**SC&A REVIEW OF PROPOSED NIOSH
DOSE RECONSTRUCTION METHODS FOR
URANIUM AND THORIUM AT PANTEX PLANT
DURING 1951–1957 AND 1984–1991**

**Contract No. 200-2009-28555
Revision 2**

June 2013

Figure 1. ^{235}U Excretion Rates (dpm/d) versus $^{234}\text{U}/^{238}\text{U}$ Ratios in Urine Bioassays of W28 Workers

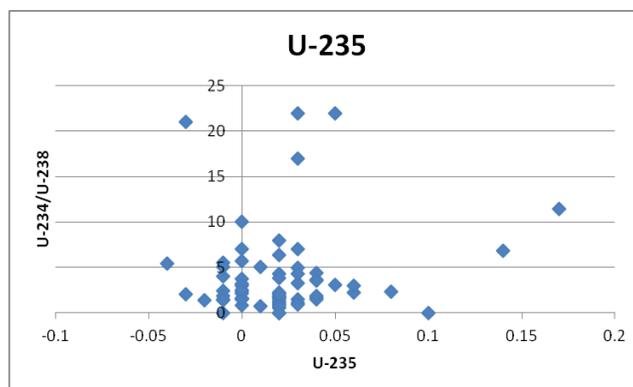
(E) There are six W28 workers with high excretion rates of U-235 (>0.06 dpm/d). For five of those workers, the ratio of U-234 to U-238 excretion rates are higher than 2, as illustrated in Figure 1.

The measurable concentration of U-235 in urine and the high U-234/U-238 ratios of activity in urine are all signs of EU exposure.

Figure 2. $^{234}\text{U}/^{238}\text{U}$ Activity Ratio in Urine of W28 Workers versus ^{234}U Results in dpm/d

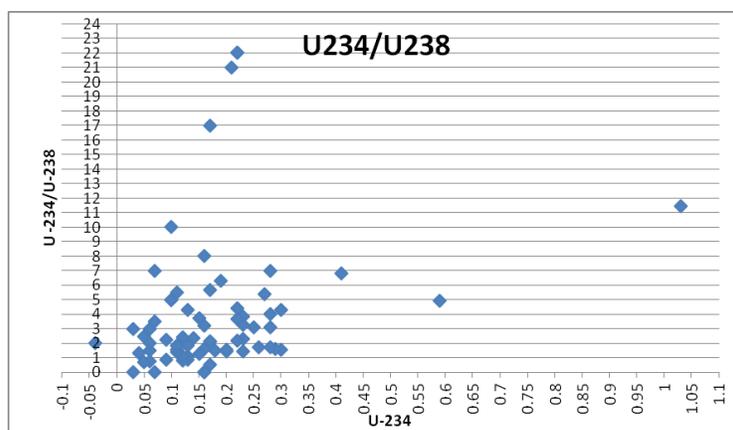
(G) Figure 2 shows the U-234/U-238 ratio versus U-234 results. It can be seen that workers had exposures to EU and natural uranium, besides DU, if laboratory results are considered reliable.
